Technical Bulletin

Radiator filter issues

This bulletin is to provide information about two issues with the radiator filter (P/N: 003-003082-XX) for the products listed below.

The following image shows the correct orientation of the filter folds and location of the label:

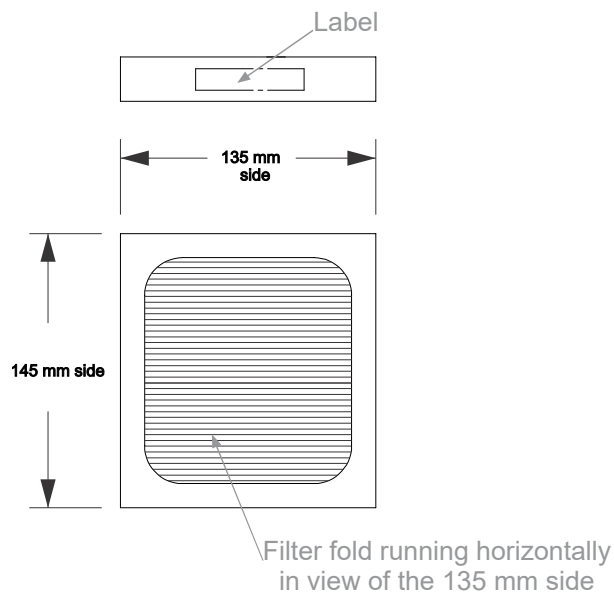
- The filter orientation is incorrect as the folds are running vertically not horizontally, such as the pleats are on the 145 ± 1 side not on the 135 ± 1 side. Christie has confirmed this does not affect functionality.
- The Air Flow label placement is incorrect. The label is currently placed on the 145 mm side of the filter and but it should on the 135 mm side.

Christie has notified the manufacturer of the filter about these issues; however, the current filters can be used as is as functionality is not affected.
